BALLYNAHONE LDES ACP REF. ABP-321384-24

Further Information Response Report

Prepared for:
FuturEnergy Ireland Development DAC

Date: March 2026

Figure 2-1: Electrolyte Management System

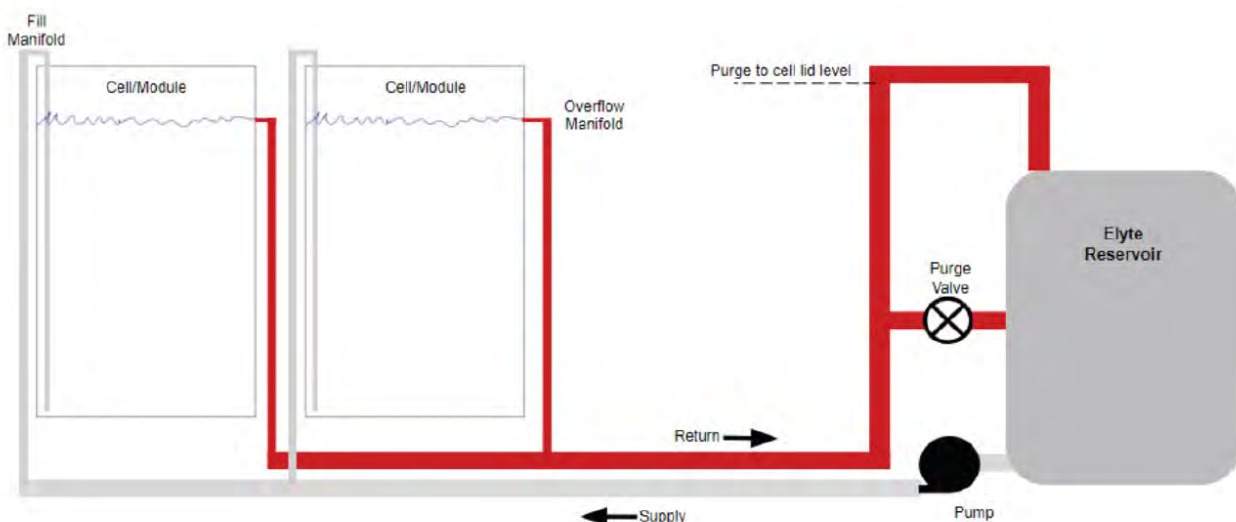
Provide details of the chemical composition of the electrolytes used in the proposed batteries, all associated risks and proposed mitigation measures for same.

- b) Provide details of the chemical composition of the electrolytes used in the proposed batteries, all associated risks and proposed mitigation measures for same.

Electrolyte levels fluctuate within the cells due to evaporative and hydrolysis losses as a normal part of system operation. The Form Energy battery contains an electrolyte management system that refills cells when necessary, utilising a pump around method from a central reservoir that acts as the supply and reserve. The electrolyte management system can be activated by the Battery Management System (hereafter BMS) during idle, charging, and discharging conditions. Modules are designed with fill manifolds that connect to each cell.

The system is also designed with overflow protection connected to the central reservoir, as well as secondary containment within the enclosure in the event of an electrolyte spill. In addition, Form's enclosures include a leak detection and monitoring system, with associated faults and alarms from the BMS that send alerts to the Energy Management System and Future Energy Ireland's Supervisory Control and Data Acquisition (SCADA) system. Upon detecting a leak, the system automatically cuts off power to the enclosure. As needed, designated personnel will immediately address any issues according to the site-specific emergency response plan.

PROJECT	CLIENT		
BALLYNAHONE LONG DURATION ENERGY STORAGE	FUTUREENERGY IRELAND DEVELOPMENT DAC		
SHEET	Date 19.09.24 Project number P23-117 Scale (@ A1-) 1:500		
SITE LAYOUT PLAN 1:500 SHEET 2 OF 3		Drawn by POR	Rev P02
		Checked by TB	
		Drawing Number P23-117-0100-0005

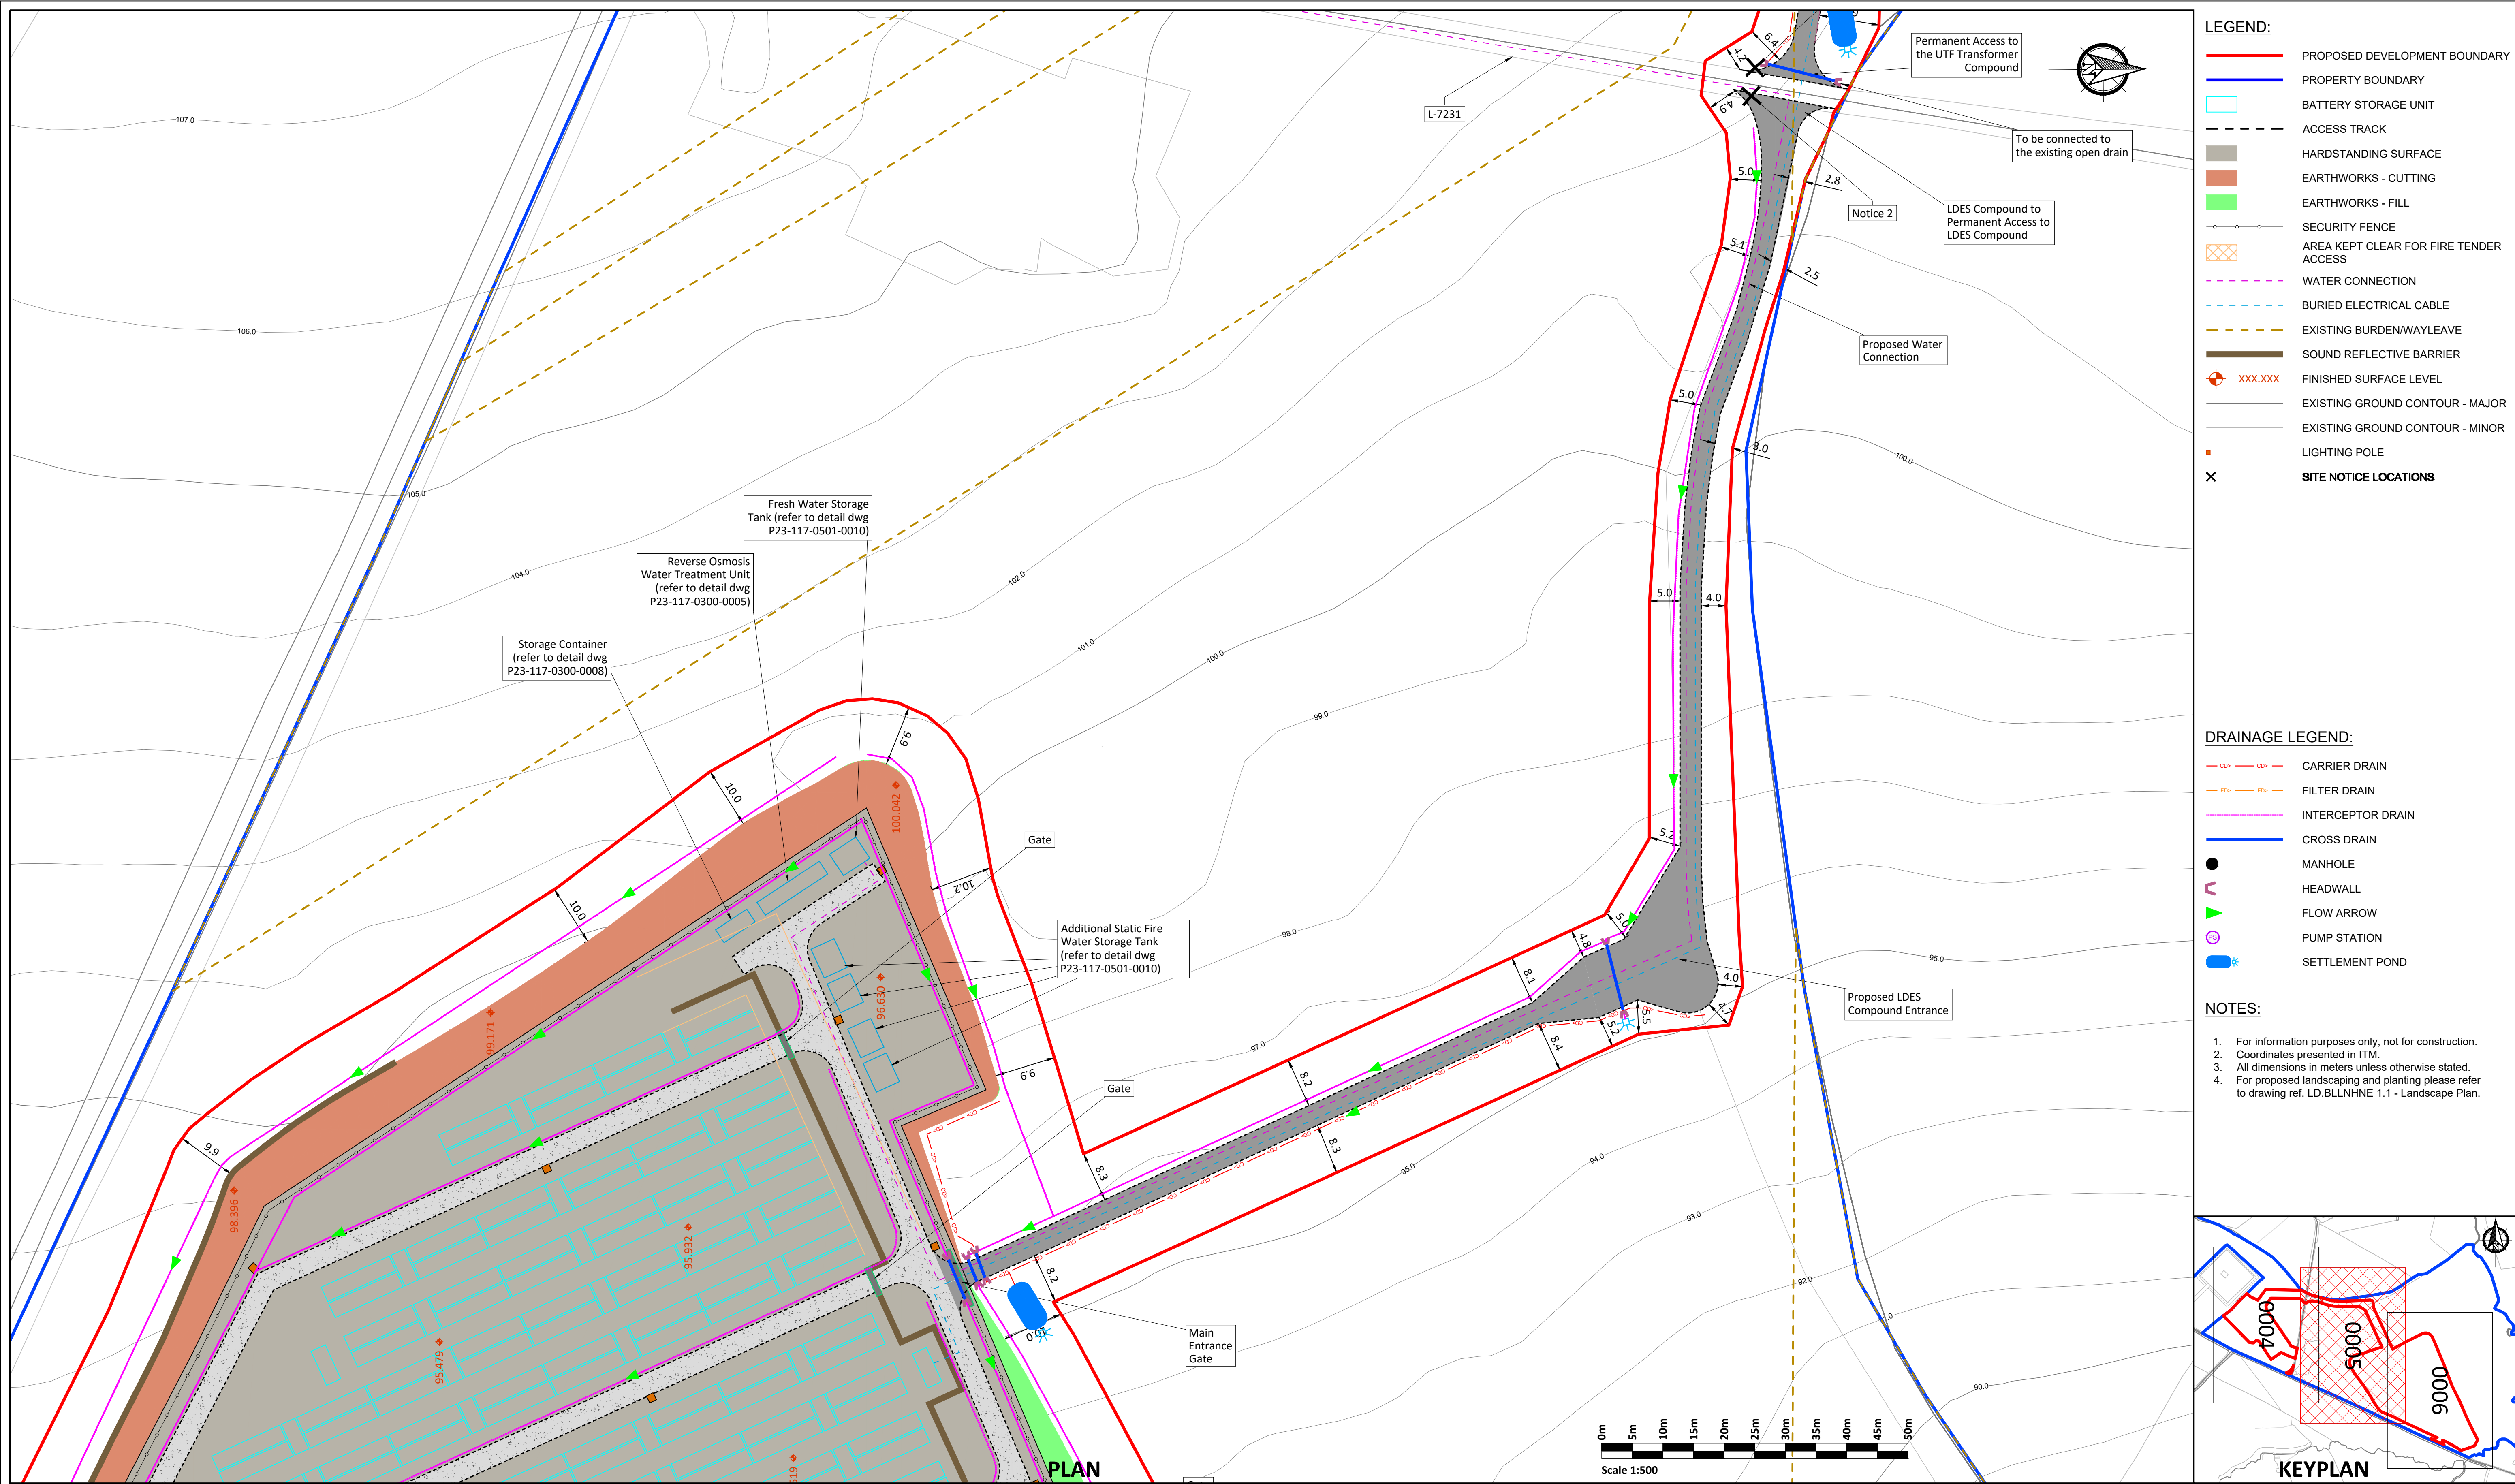
Details of the quantity and confirmation of how firefighting water will be sourced and/or retained within the proposed development site. This should be to the UK National Fire Chief's Council (NFCC) Grid Scale Battery Energy Storage System Planning - Guidance for the FRS (Fire & Rescue Services), which states that provision should be made for BESS units to provide 1,900 litres of water for 2 hours, as a minimum unless it can be demonstrated that another amount is appropriate. Revised drawings and necessary agreements to be provided to demonstrate feasibility of same.

- a) Details of the quantity and confirmation of how firefighting water will be sourced and/or retained within the proposed development site. This should be to the UK National Fire Chief's Council (NFCC) Grid Scale Battery Energy Storage System Planning - Guidance for the FRS (Fire & Rescue Services), which states that provision should be made for BESS units to provide 1,900 litres of water for 2 hours, as a minimum unless it can be demonstrated that another amount is appropriate. Revised drawings and necessary agreements be provided to demonstrate feasibility of same.

There is sufficient space within the BESS compound to provide additional dedicated water storage for firefighting purposes in addition to the mains fed tank. It is calculated that an additional 4 no. tanks of the same dimensions included in the planning design would provide dedicated static storage of 220,000 litres. This would provide sufficient dedicated static storage of fire water to exceed the latest NFCC requirements. 4 no. dedicated fire water storage tanks have been included in the design to supplement the original mains fed tank. These tanks shall be reserved exclusively for storage of fire water throughout the lifetime of the development.

Refer to the appended drawing number **P23-117-0100-0005** for the location of the additional fire water storage tanks. Refer to drawing number **P23-117-0501-0010** as submitted with the original planning application for a standard detail of these water tanks.

PROJECT	CLIENT		
BALLYNAHONE LONG DURATION ENERGY STORAGE	FUTUREENERGY IRELAND DEVELOPMENT DAC		
SHEET	EMERGENCY ENTRANCE ROAD MARKINGS AND SIGNS	Date05.12.25Project numberP23-117Scale (@ A1-)1:125	RevP01
		Drawn byCS	
		Checked byLD	
		Drawing NumberP23-117-0600-0003

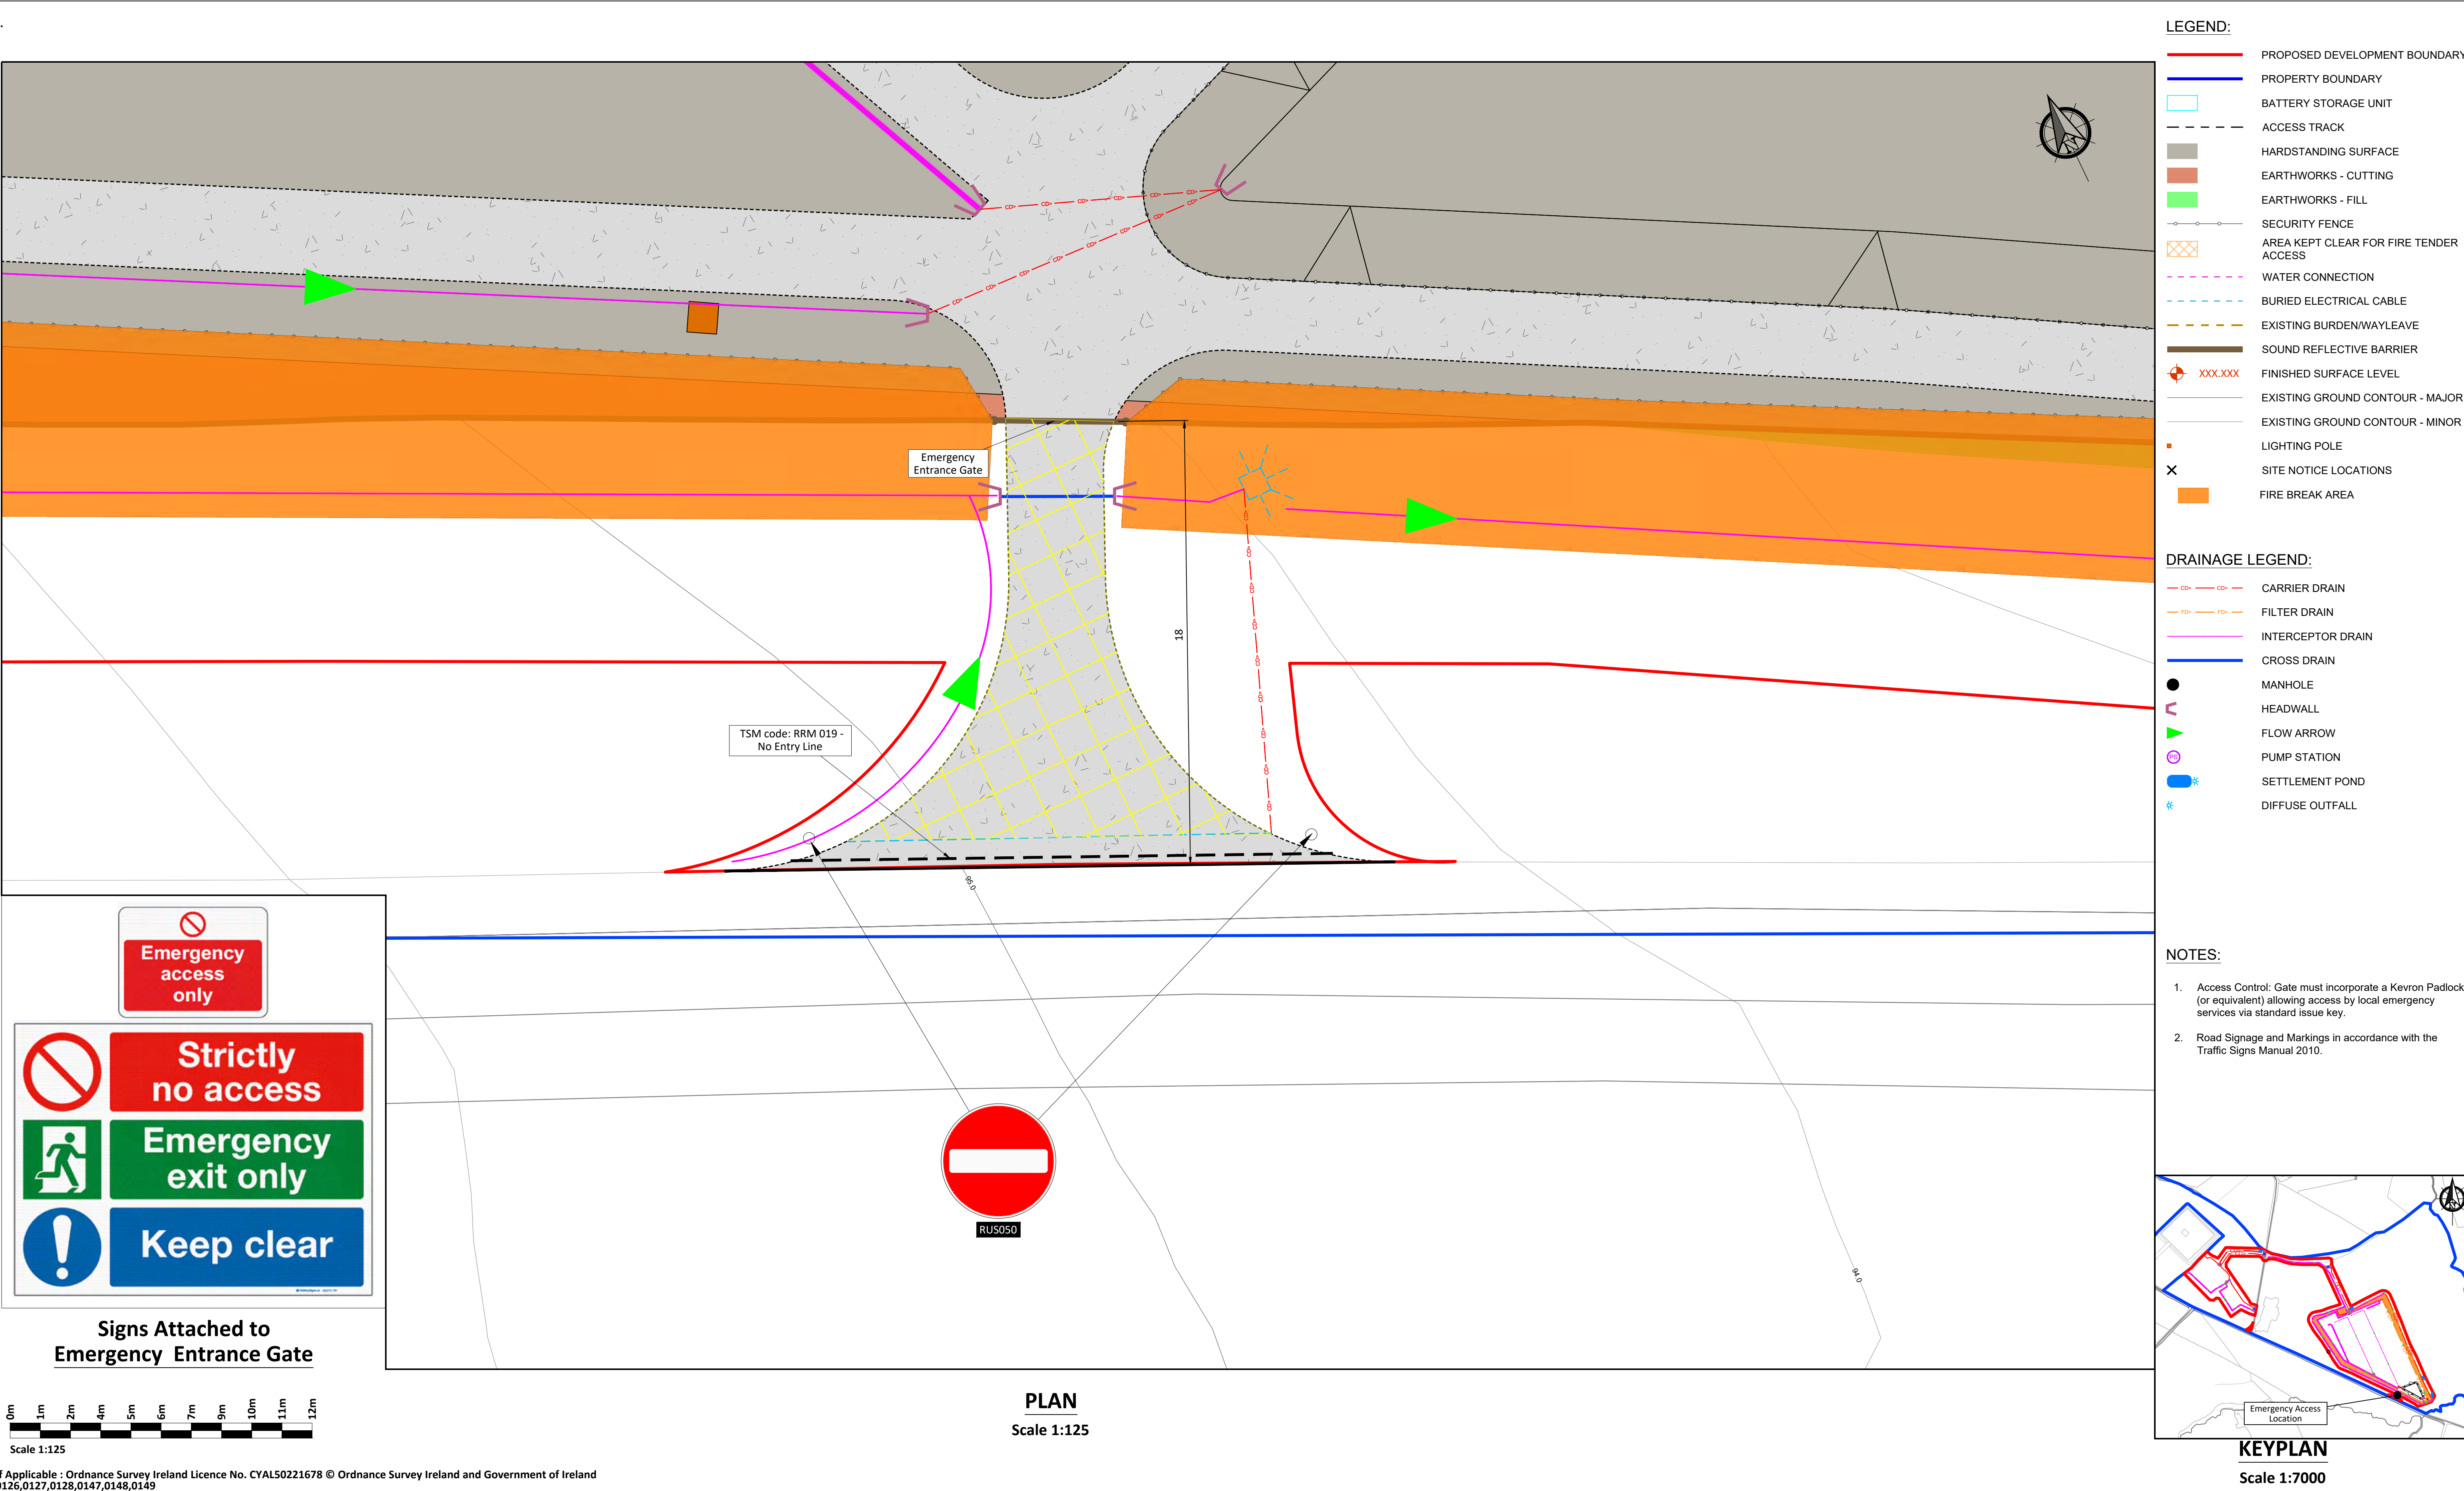
Revised drawings to demonstrate the provision of a perimeter ring road solution with more than one access point from the public road for fire authority vehicle access. The access points are recommended to be positioned to account for opposite wind direction.

- d) Revised drawings to demonstrate the provision of a perimeter ring road solution with more than one access point from the public road for fire authority vehicle access. The access points are recommended to be positioned to account for opposite wind direction.

We refer the Commission to the enclosed drawing number **P23-117-0600-0003**, prepared by Fehily Timoney and Company. This shows the addition of a further entrance to the southern boundary of the site, onto the L-7221 public local road, for emergency use only.

This additional emergency access point is designed to be maintained clear of obstruction at all times. This is made clear through the no entry road markings, signage, and yellow box provided in drawing number **P23-117-0600-0003**. Given its permanent closure to all vehicular traffic other than emergency service vehicles, the existing forward visibility splays are considered safe for the entrance requirements, providing 100 metres of visibility to the southeast and in excess of 300 metres to the northwest without mitigation. Consequently, the forward visibility currently provided is deemed suitably safe for emergency use without requiring any additional mitigation measures. Maintenance of the adjacent public road corridor will remain the responsibility of the relevant local planning authority.
